# ECO S och ECO M

## kvalitetsavvikelse

# ECO S and ECO M

## Quality deviation

Bild 1: Enhets baksida med felaktigt monterat nättaggregat (utan taggbricka).

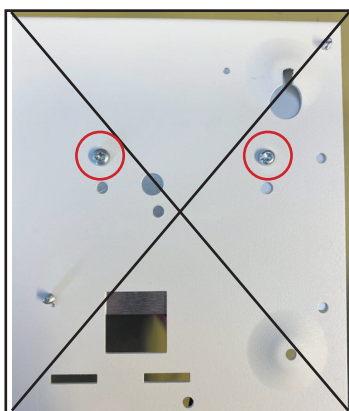
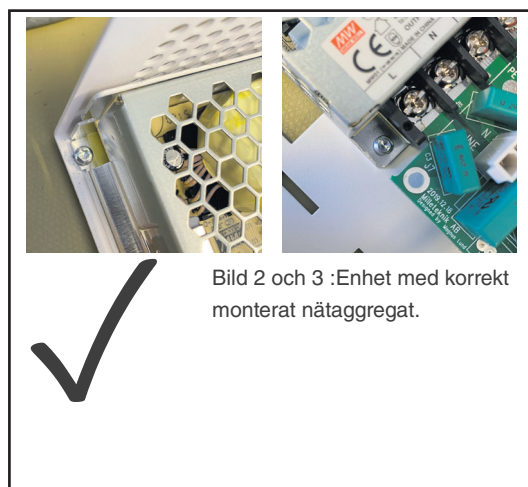
Vid slutmontering har komponenten nättaggregat skruvats i skåpets baksida (bild 1) istället för insidan av kapslingen. Detta ger en risk att skyddsjordningen av komponenten inte fungerar som avsett.

Komponenten, nättaggregatet kan då få en potentialskillnad mot inkommande skyddsjord. Detta kan leda till åtkomst av spänningsförande ytor på enbart på komponenten.

Avvikelsen påverkar ej enhetens funktion eller driftsäkerhet. Risk för stöt uppkommer vid samtidig beröring av komponenten nättaggregat och samtidig beröring av en skyddsjordad yta. Det är bara vid service, när luckan är öppen, som risk för mindre stöt kan uppstå. Denna stöt är ofarlig. En jordfelsbrytare löser ut vid 30 mA och uppmätt ström mellan nättaggregat och inkommande skyddsjord är ca 6 mA. Detta utgör ingen personsäkerhetsrisk men kan uppfattas obehagligt.

Åtgärder är vidtagna för att avvikelsen ej skall uppkomma igen med utbildning, förbättrade instruktioner för korrekt montering (bild 2 och 3) av nättaggregat samt utökade stickprovskontroller.

Ja, skrupåse med instruktion finns att tillgå kostnadsfritt, kontakta support för mer information.

Figure 1: Unit back with incorrectly mounted power supply (without tag washer).

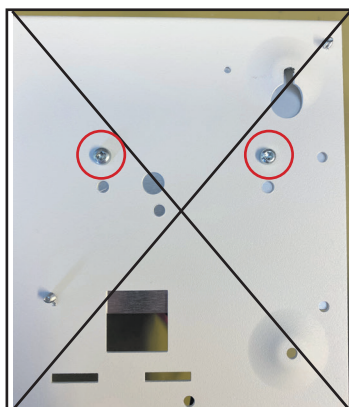
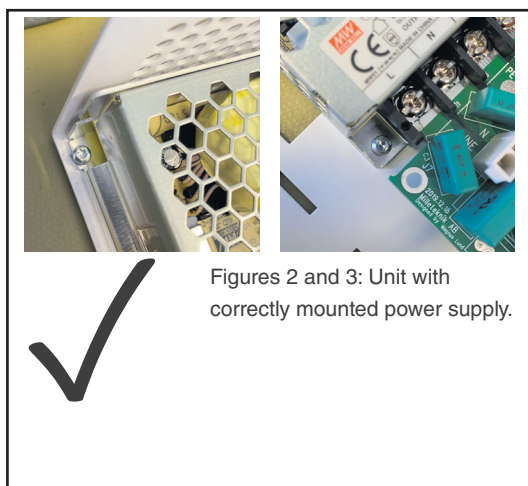
At final assembly, the component power supply has been screwed into the back of the cabinet (Figure 1) instead of the inside of the enclosure. This poses a risk that the protective earth of the component does not work as intended.

The component, the power supply, can then have a potential difference to the incoming protective earth. This can lead to access of live surfaces only on the component.

The deviation does not affect the unit's function or operational reliability. Risk of shock arises when simultaneously touching the power supply component and simultaneously touching a protective earthed surface. It is only during service, when the door is open, that there is a risk of minor shocks. This shock is harmless. An earth fault circuit breaker trips at 30 mA and the measured current between the power supply and the incoming protective earth is approximately 6 mA. This does not pose a personal security risk but can be perceived as unpleasant.

Measures have been taken to ensure that the deviation does not recur with training, improved instructions for correct installation (Figures 2 and 3) of power supplies and extended random checks.

Yes, screw bag with instructions is available free of charge, contact support for more information.
